**Re: Compark Village South – 2nd Review
F1 AMD 2 – Multifamily – SP21-118**

Compark Village South – F1 AMD 2 – Multifamily – Site Plan - Comments from Plan Sheets

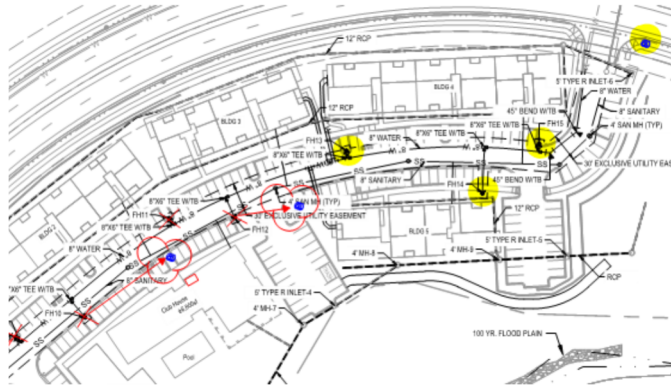
Response: Fire Life Safety signature block has been added.
13. The hydrant distribution has been redlined to accommodate response more effectively; the overall utility drawing shall include the hydrant distribution for all filings and the following criteria. See below for information on hydrant location criteria and on revisions to the hydrant layout (hydrants have been deleted, added, and relocated while shown at entry ways if not currently addressed): *Partially satisfied; applicant has noted/ acknowledged/addressed with current submittal though a fire hydrant is still required at the eastern intersection of Belford Ave and Deer Track Drive and a hydrant is required at the "T" of Deer Track Lane and Wolf Fox Street (also shown as Bunny Hop Lane... this issue should be addressed with the next submittal, as well) and relocate the fire hydrant in front of building 1. This hydrant is located in*

the island west of the east end of the building. The island shall be moved over 5 parking spots to align this hydrant between both building 1 and building 2 (as fire hydrants should be within 40 feet of the building to be served). Address these issues when resubmitting:

- Hydrants shall be located no further than 40 feet of the building to be served.
- Hydrants serving buildings with fire suppression systems shall be located in the general area of the riser room.
- Divided roadways require that hydrants be spaced at 250-foot intervals on a stagger (on each side of the road); these hydrants shall be located 500 feet apart on each respective side of the road.
- Hydrants shall be located at the entry into each sub area.
- Hydrants shall be located at the end of most cul-de-sacs.
- Hydrants shall be located at the corners of all streets where possible
- Hydrant spacing shall meet the requirements of the 2018 IFC Chapter 5 and appendix B and C

Response: Hydrants have been added/relocated per the markups provided.
